Department of Planning and Zoning

TO: Design Advisory Board
FROM: Scott Gustin *AS*
DATE: April 12, 2016
RE: 16-0958SP, 316-322 Flynn Avenue

Request: Sketch plan review of project to remove deli building and residence and to replace with four story mixed use building with thirty apartments and two commercial spaces with associated parking lot.

PINE & FLYNN - SITE PLAN

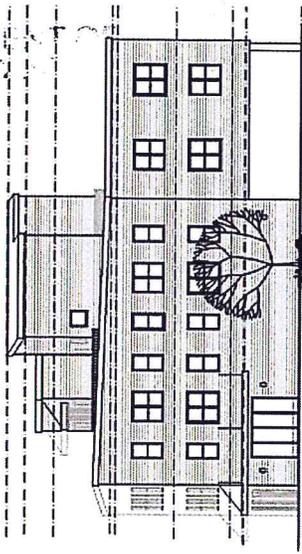
Reconstructed surface parking is placed to the side and underneath the building. The existing streetfront pavement will be removed and replaced with the new building and associated walkway and stairs. The building mass screens some of the parking from the street. Where the building is elevated above the parking, there is no screening. This criterion requires screening of this street-level parking with landscaping, public art, or other design amenities. Better yet, the parking could be more fully enclosed by the building.

Dimensionally, the parking spaces and back-up distances are smaller than the standard. Proposed parking spaces are just 18' deep, whereas 20' is the standard. Back-up length for the 90-degree parking spaces is just 20,' whereas the standard for such spaces is 24.' While some dimensional flexibility is allowed under the standards of Article 8, the applicant must demonstrate that the proposed layout will be functionally adequate. The sketch plans show no safe and unobstructed route, physically separated between vehicles and pedestrians, connecting pedestrians to the building entries or public sidewalk. Such route must be provided.

Exposed surface parking is limited enough (just 8 spaces) that shade trees are not required. Additional landscaping should be installed at the northwestern corner of the parking lot to provide screening from the street.

All utility lines must be buried. No ground-mounted mechanical equipment is included in the proposal. A trash and recycling enclosure will be provided at the northeast corner of the parking area. No enclosure details have been provided and must be included in the permit application. The dumpster must be set on a concrete pad.

PINE & FLYNN - ELEVATIONS

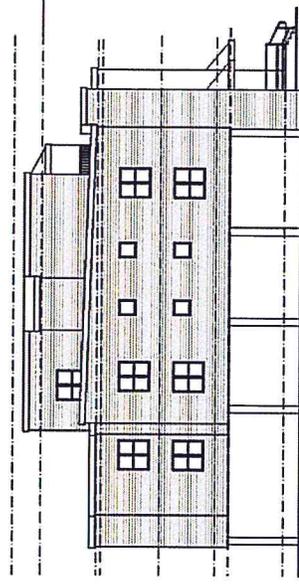
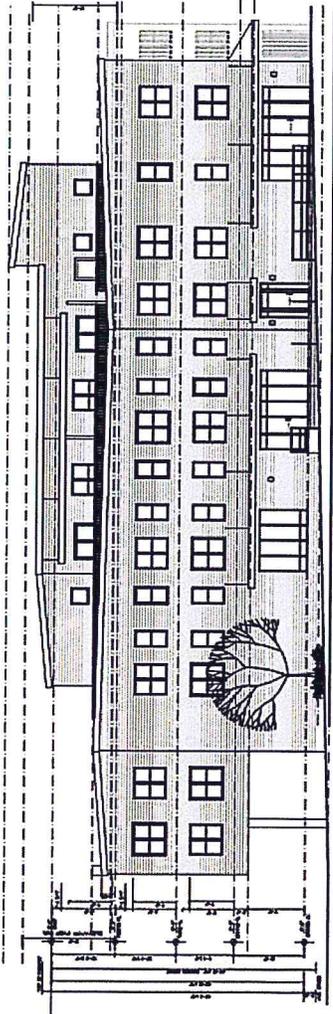
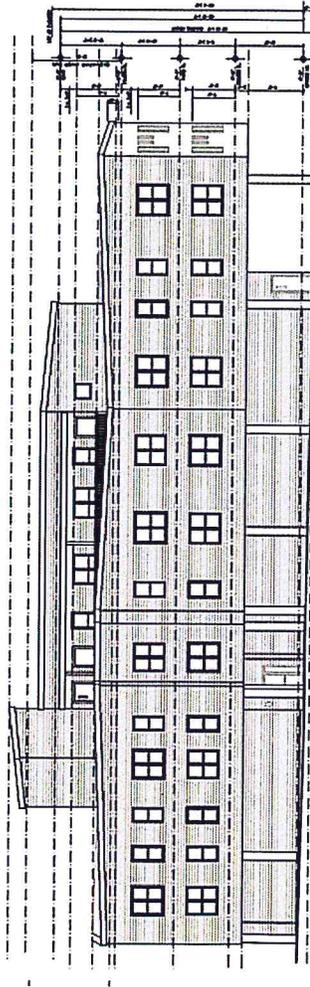
While the proposed building is significantly larger than that in the prior proposal, it is not out of context with other existing buildings in the area, particularly along Pine Street to the north. The proposed building is very similar in appearance to other recently constructed apartment buildings: boxy and angular with some variation in exterior color and building plane to break up perceived mass. There is no differentiation at the ground level except where the building is elevated on poles above the parking. Improvement is needed. While not an especially tall building, greater distinction is needed for the ground level – to strengthen its pedestrian interface and to separate it from the upper stories. More than half of the building is hoisted in the air on columns. While fundamentally this arrangement can work, its appearance from the street is awkward and contradictory to presenting an active and inviting face to the street. Ground level parking under the building is acceptable. The exterior building walls should be extended across most or all of the perimeter of the parking (of course leaving voids for garage entries). Instead of windows, grated openings could be used for ventilation. Doing so would provide greater continuity and strength to the building's ground level.

The proposed building exhibits two fenestration patterns, both of which are consistent with the overall appearance of the building. The ground level fenestration presents as that of a shop front while the upper stories incorporate a fenestration pattern more consistent with an apartment building. Fenestration throughout is appropriately scaled and suited to its intended purpose. The front entries are embellished with projecting awnings over the doorways.

As proposed, the building employs physical step-backs of its façade along Pine Street and Flynn Avenue to break up its perceived mass. The front entries are defined with shop front fenestration and awnings overhead. As noted above, there is relatively little that distinguishes the street level of this building from the upper stories. Greater street level detail is needed. This criterion spells out a number of options such as varying building materials, architectural features, and recessed entries.

No building materials are specified in the sketch plans, but the elevation drawings imply that the structure will be clad entirely in corrugated metal siding with metal coping along the roof edges. This material is acceptable for new construction; however, as noted above, a different material along the ground level should be used. Window, roofing, and awning materials are not noted. All exterior building materials must be specified in the permit application.
